**Subject: Beaver Valley Power Station, Unit No. 1
Docket No. 50-334, License No. DPR-66
License Amendment Request No. 292**

Pursuant to 10 CFR 50.90, FirstEnergy Nuclear Operating Company (FENOC) requests an amendment to the above license in the form of changes to the technical specifications. The proposed amendment would update the technical specification heatup and cooldown curves, and the overpressure protection setpoints and Bases to apply for up to 22 effective full power years (EFPY). The applicability for the current curves will expire at 16 EFPY. Therefore, approval of this license amendment is requested by February 1, 2002, to implement the amendment and allow continued operation beyond this time frame.

Beaver Valley Power Station, Unit No. 1
License Amendment Request No. 292

FIGURE 3.4-2
Beaver Valley Unit 1 Reactor Coolant System Heatup
Limitations Applicable for the First 22 EFPY

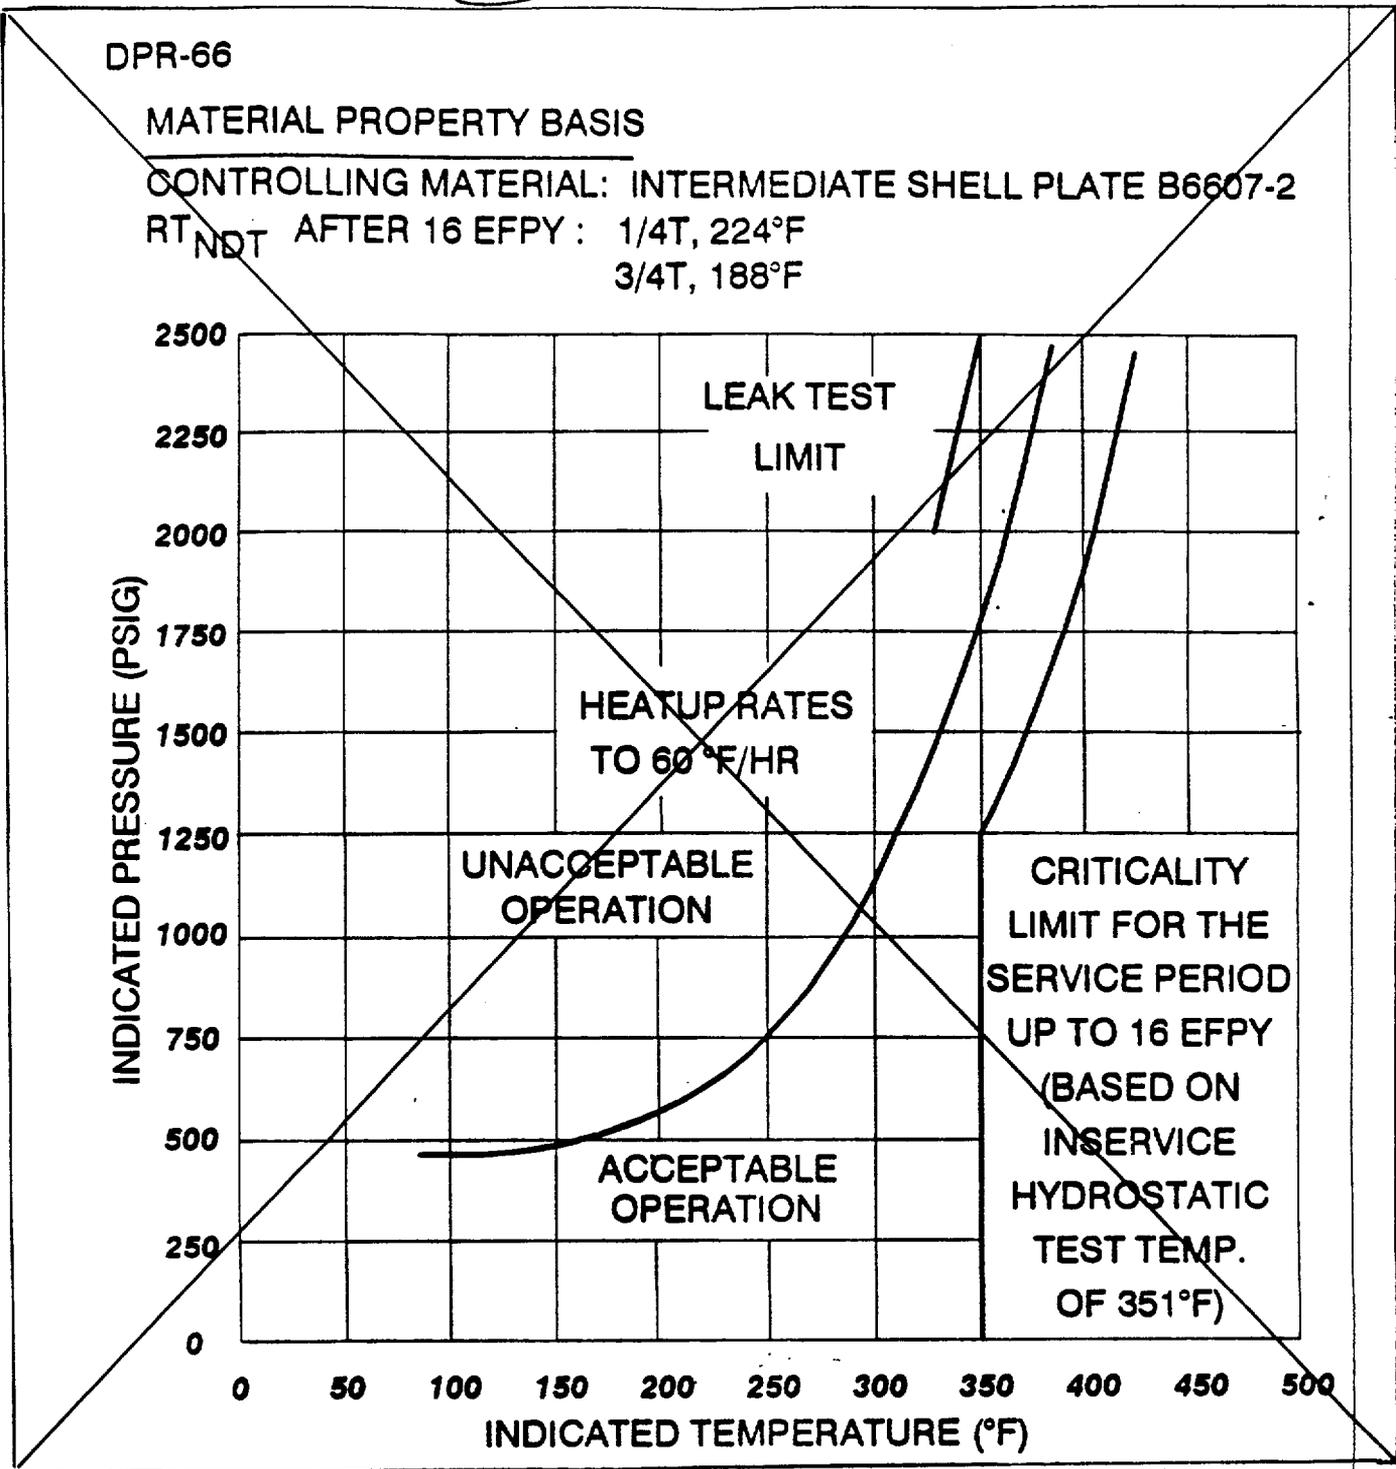
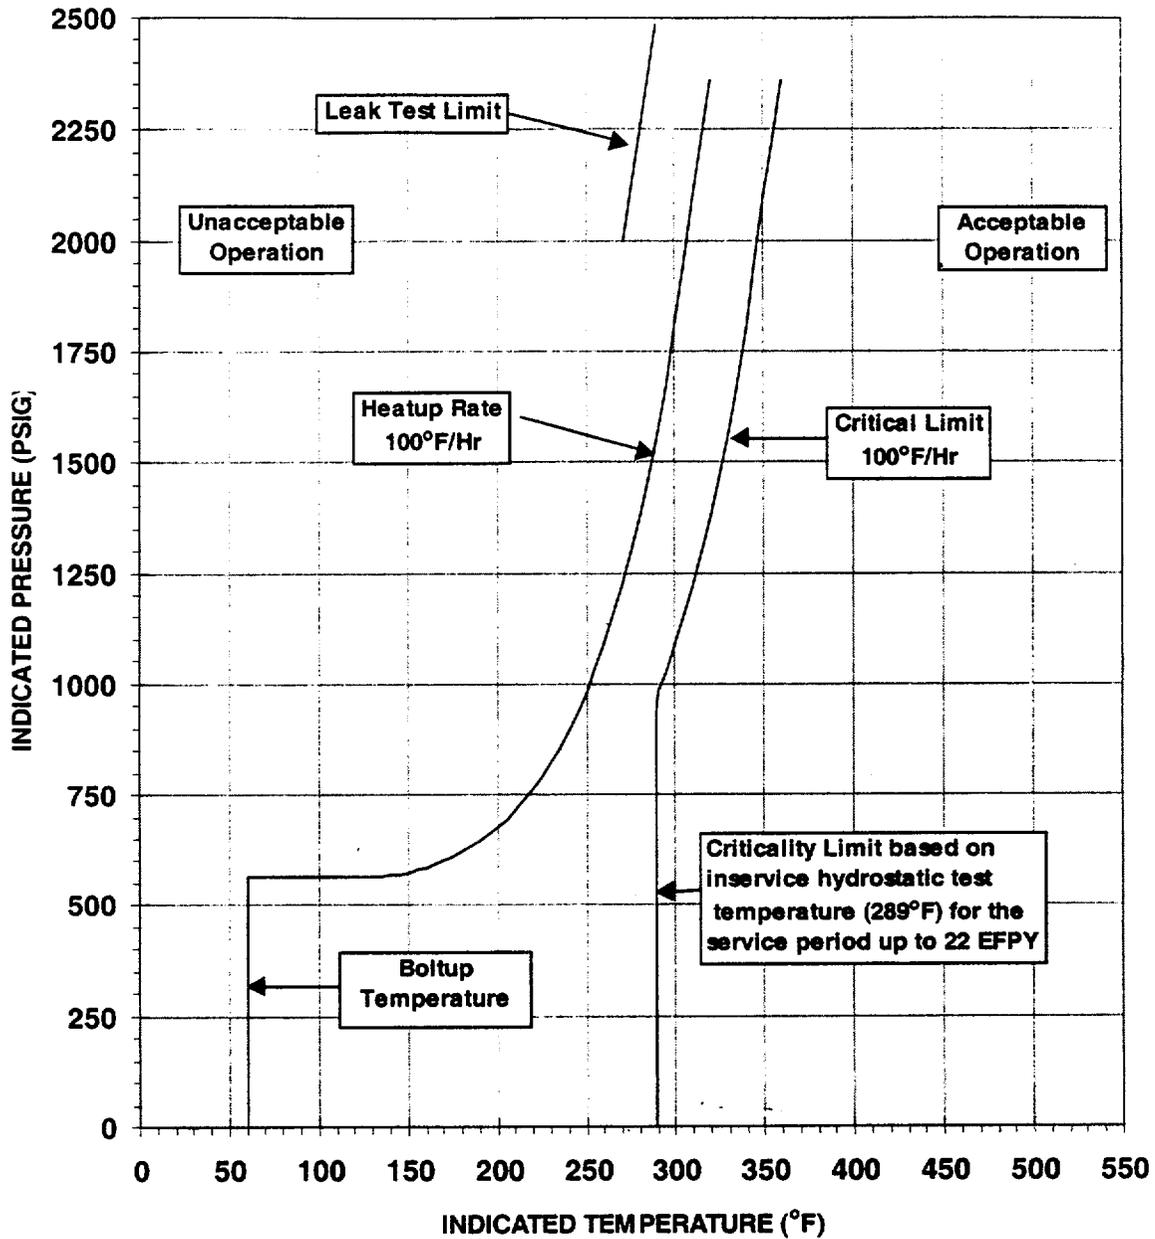
Replace with Revised Figure 3.4-2

The heatup curve, Figure 3.4-2, was generated with no margins for instrumentation errors using heatup rates up to 100°F/hour applicable for the first 22 EFPY. Based upon the analysis documented in the BVPS Unit No. 1 reactor vessel stress report, the BVPS Unit No. 1 reactor vessel is structurally adequate for at least 200 cycles of plant heatups and cooldowns not exceeding 100°F/hour in accordance with the stress and fatigue analysis requirements of Class 1 components in Section III of the ASME Code. Therefore, actual heatup and cooldown rates of 100°F/hour are acceptable for BVPS Unit No. 1 from the standpoint of reactor vessel structural and fatigue analyses.

FIGURE 3.4-3
Beaver Valley Unit 1 Reactor Coolant System Cooldown
Limitations Applicable for the First 22 EFPY

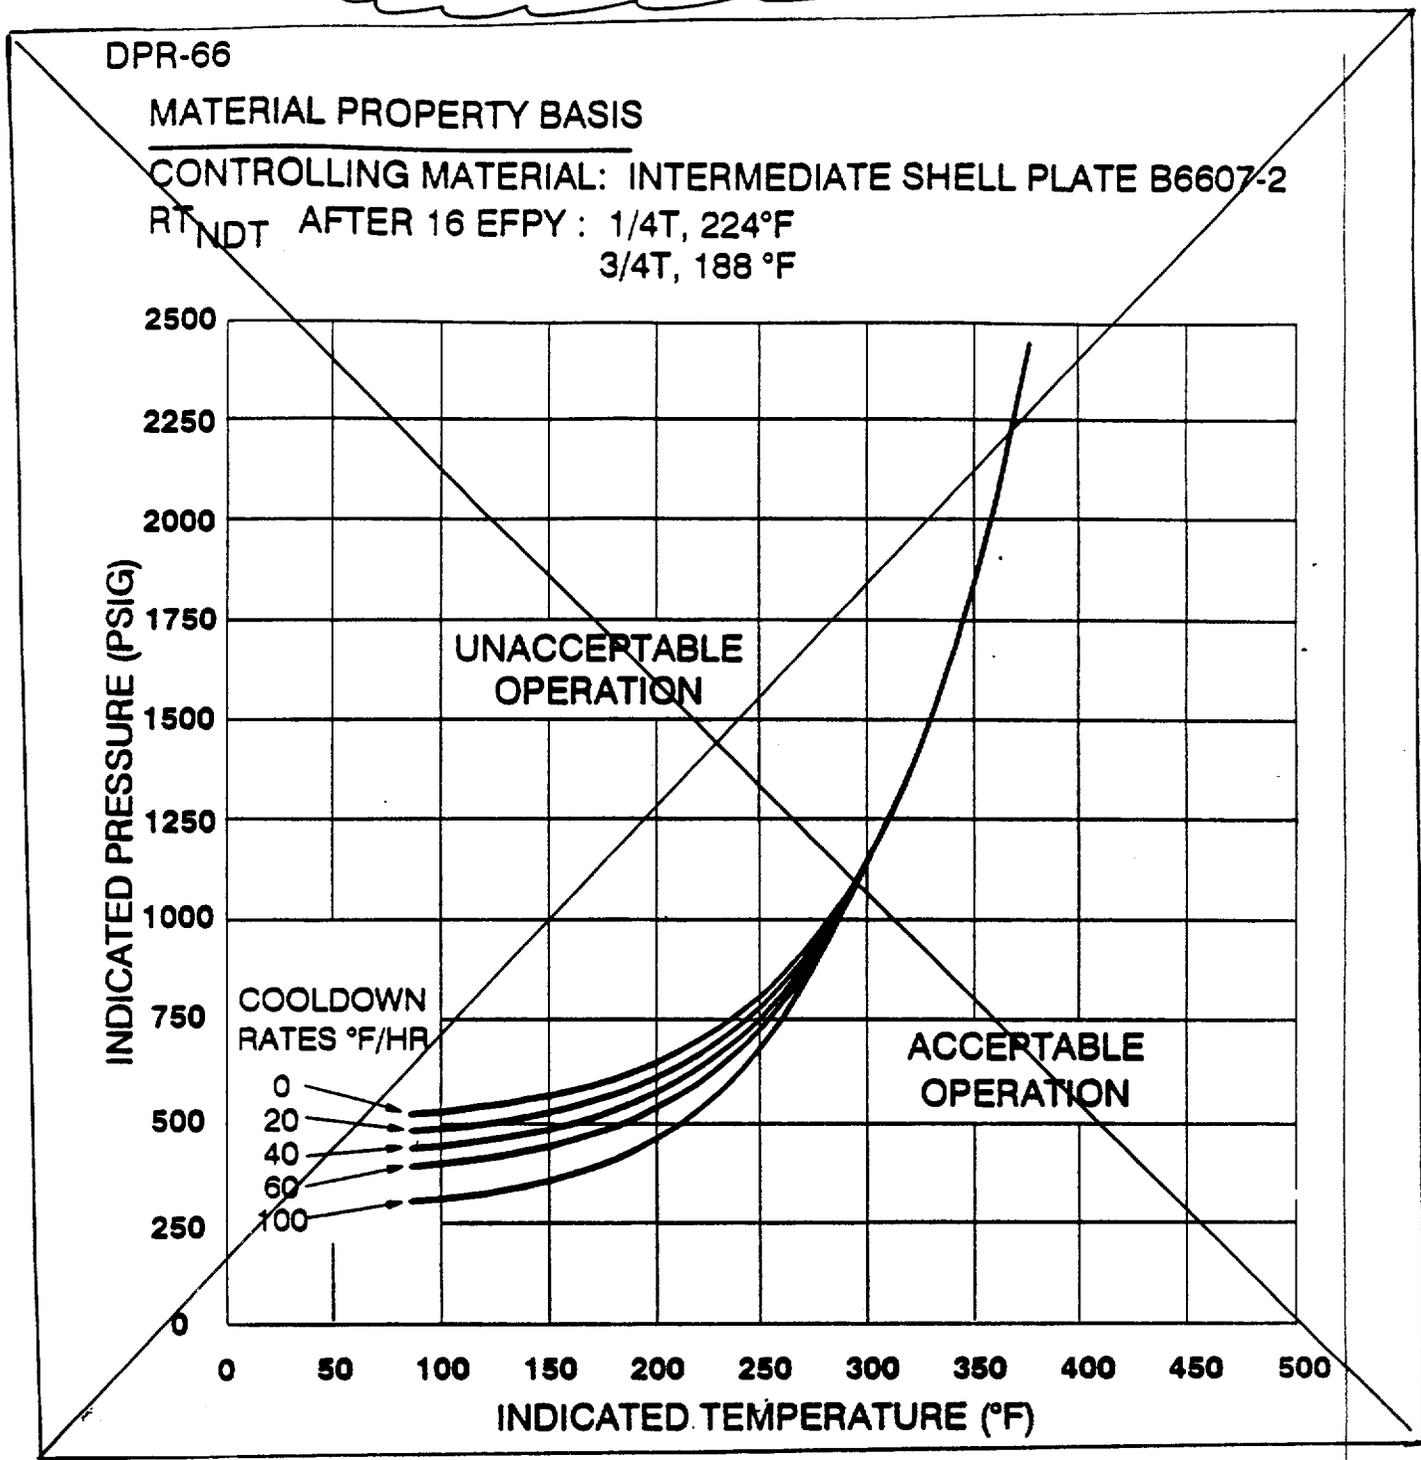
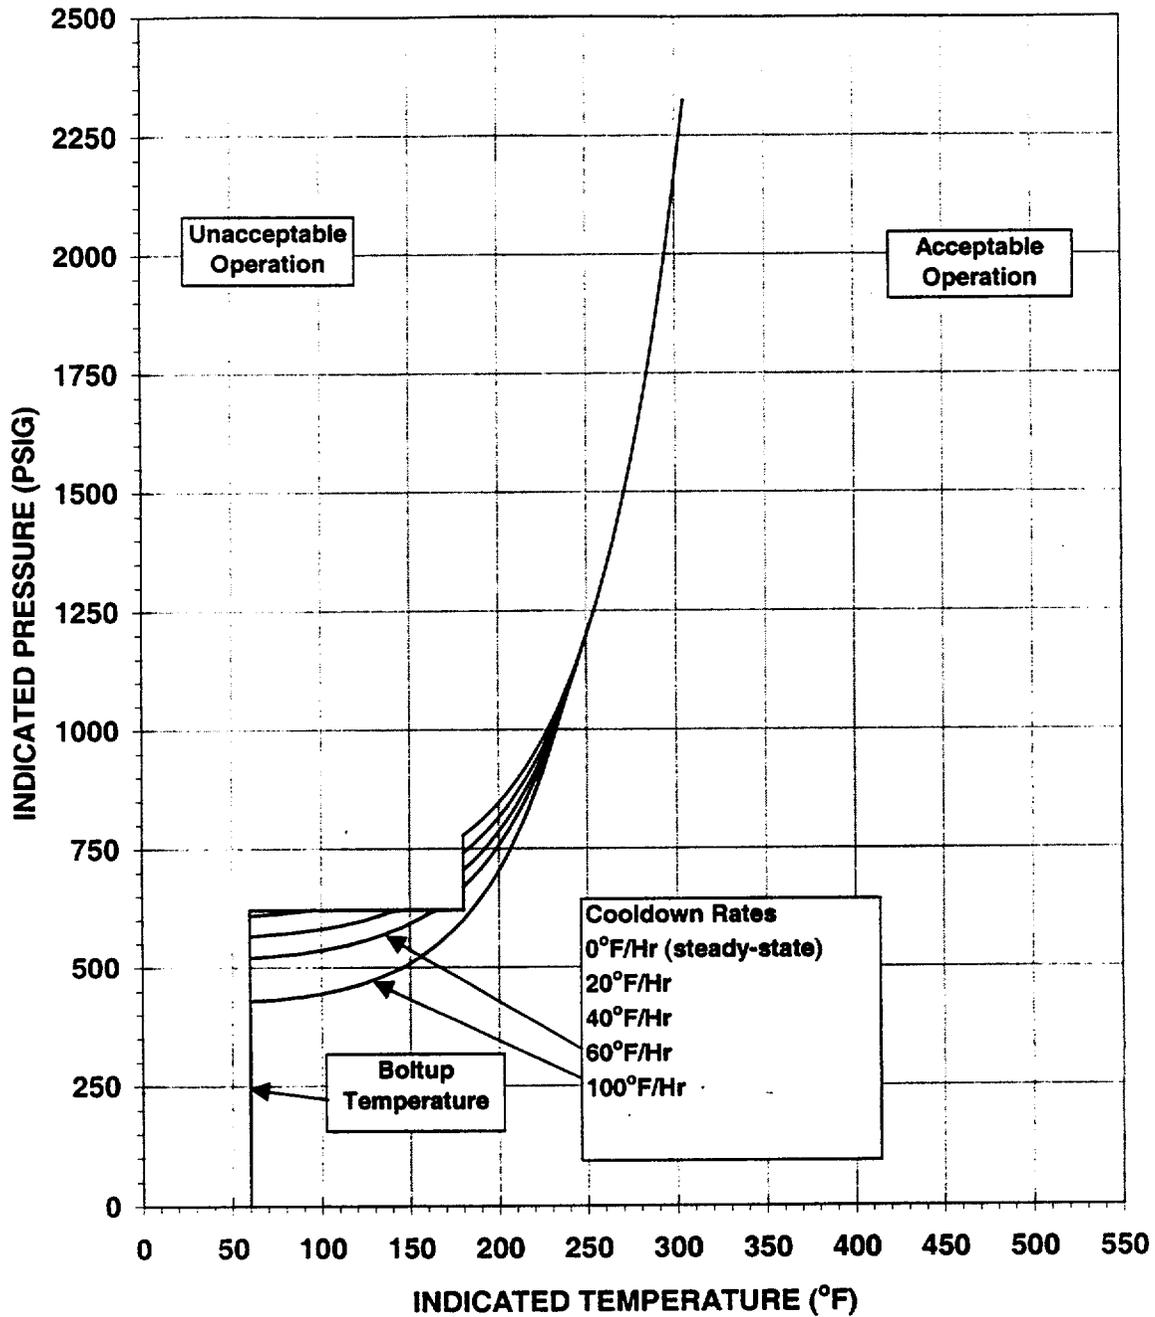
Replace with Revised Figure 3.4-3

The cooldown curves, Figure 3.4-3, are also generated for first 22 EFPY with no margins for instrumentation errors for various cooldown rates up to 100°F/hr applicable for the first 22 EFPY. For both the heatup and cooldown curves, allowable combinations of temperature and pressure for specific temperature change rates are below and to the right of the limit curves. This is in addition to other criteria, which must be met before the reactor is made critical, as discussed in the following paragraph.

FIGURE B 3/4 4-1

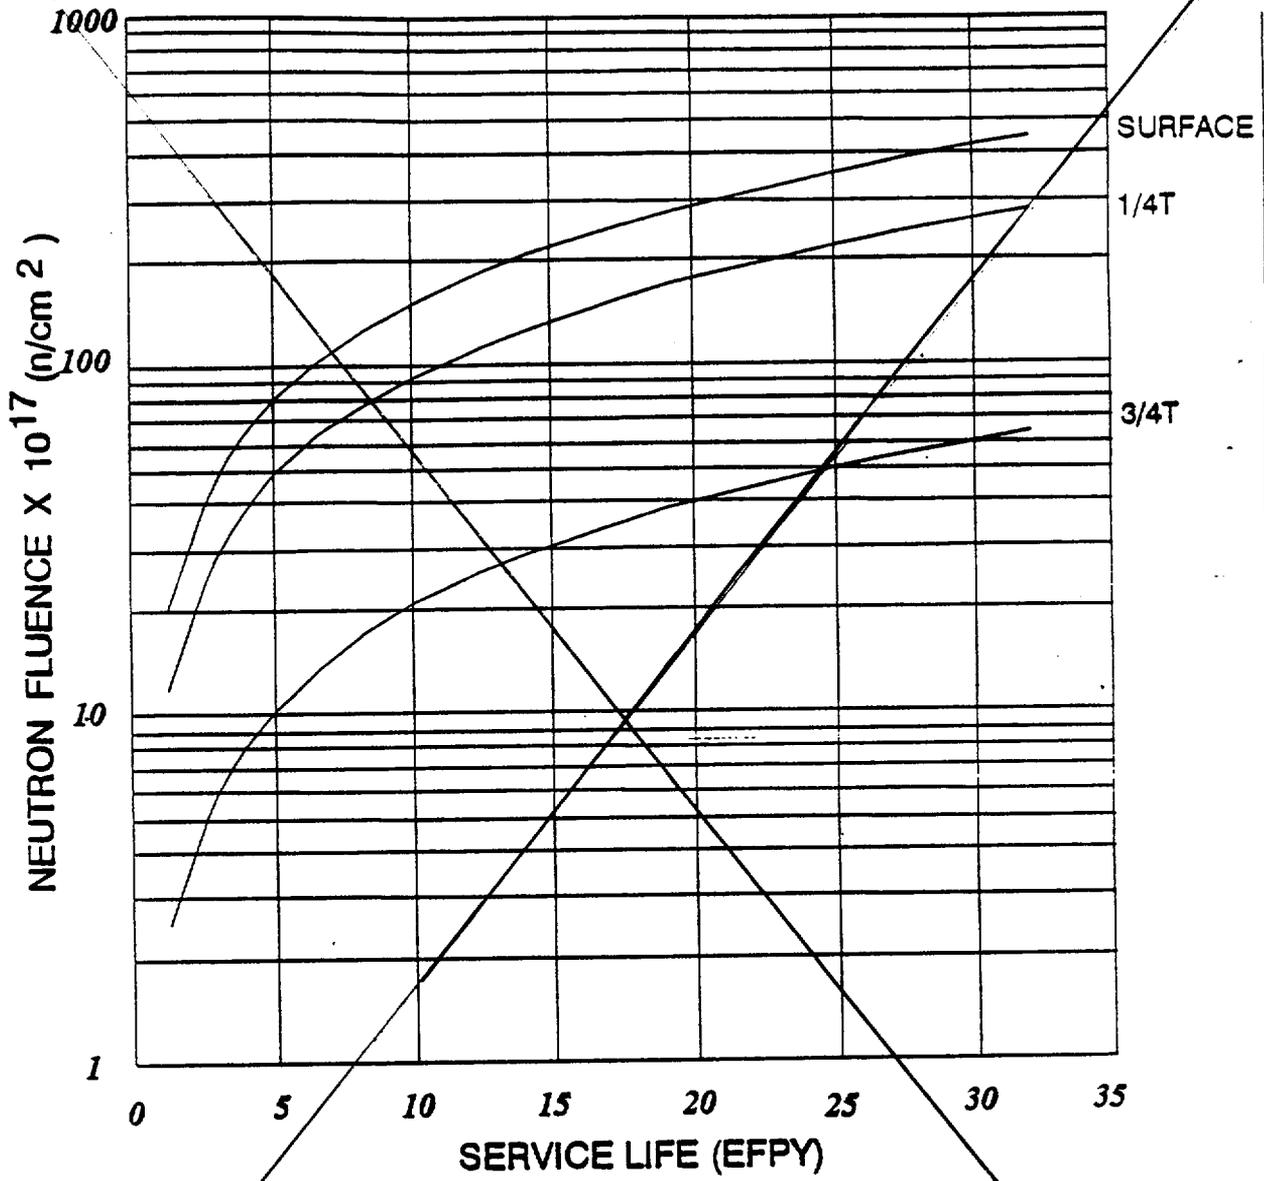
Delete this page

6. Figure B 3/4 4-1, "Fast Neutron Fluence ($E > 1$ Mev) As a Function of Full Power Service Life (EFPY)," is deleted since it is no longer used in Revision 2 of Regulatory Guide 1.99.
